**FAY, SPOFFORD &
THORNDIKE**
778 Main Street, Suite 8
South Portland, ME 04106
Toll Free: 800.835.8666
Main: 207.775.1121
Fax: 207.879.0896
www.fstinc.com

August 9, 2013

**Subject: Proposed Truck Loading Area – 56 Milliken Street
Application ID: 2013-181
Comments from City of Portland Staff**

(H) PRETREATMENT STONE DIAPHRAGM
N.T.S.

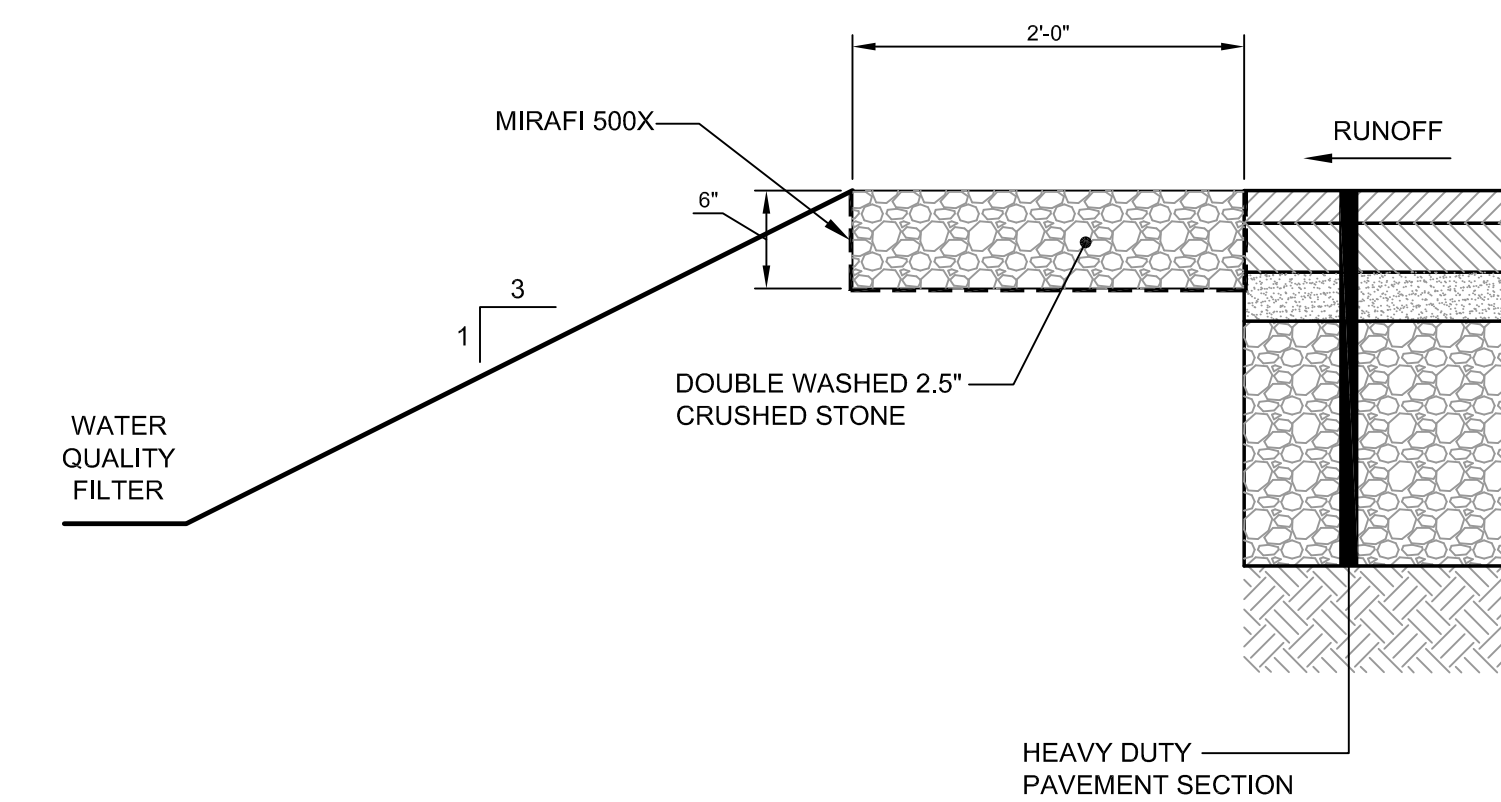
2a) Pretreatment devices such as grassed swales, grass or meadow filter strips, and sediment traps shall be provided to minimize the discharge of sediment to the underdrained soil filter. Pretreatment structures shall be sized to hold an annual sediment loading calculated using a sand application rate of 50 cubic feet per acre per year for sanding of roadways, parking areas, and access drives within the subcatchment area. The current design does not reflect these features for the management of runoff from much of the paved area.

A 175' long, two foot wide by 6 inch deep 2.5" crushed stone diaphragm has been added along the edge of the proposed pavement for pretreatment based on 40 percent void space. This provides approximately 140 c.f. of volume which more than satisfies the requirements. The long term maintenance of this pretreatment measure will involve inspection and monitoring of the stone area for sediment build up and debris. Revised Sheet C-3.0 shows the stone diaphragm. A detail has been added to Sheet C-6.1.

(L) 4'-0" PRECAST CATCH BASIN
N.T.S.

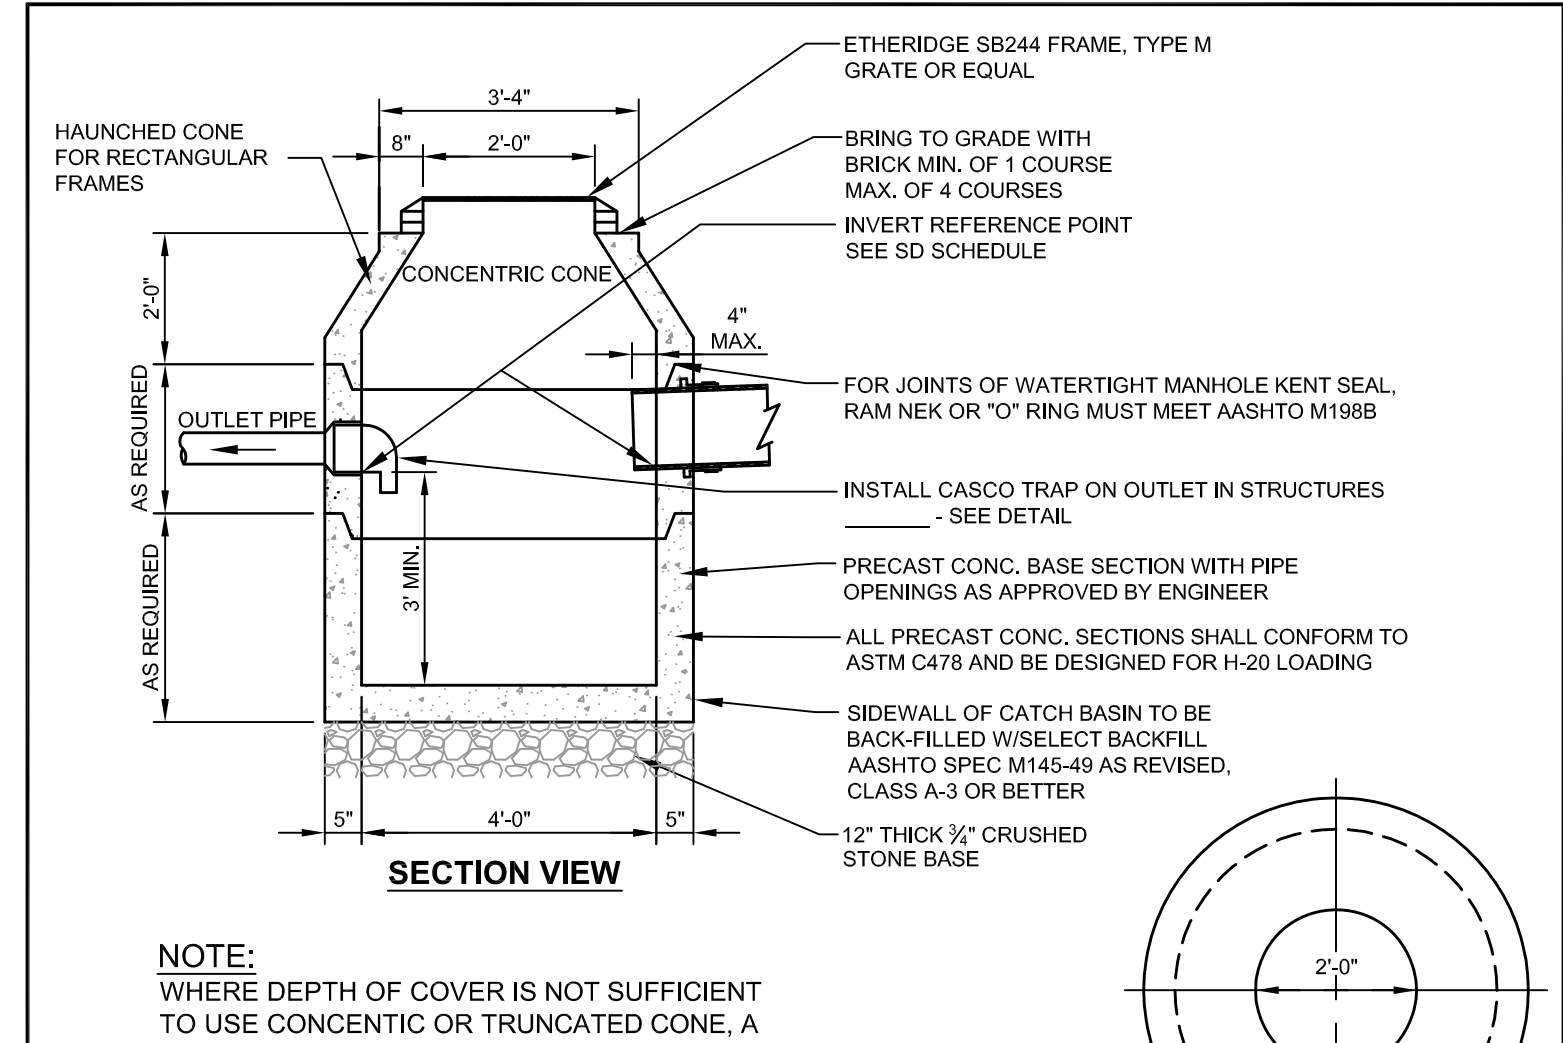
Proposed catch basins require three foot sumps.

5) The Applicant should provide a proposed catch basin detail

The catch basin detail has been added to Sheet C-6.2 and it calls for a 3' sump.

A catch basin detail has been added to Sheet C-6.2.
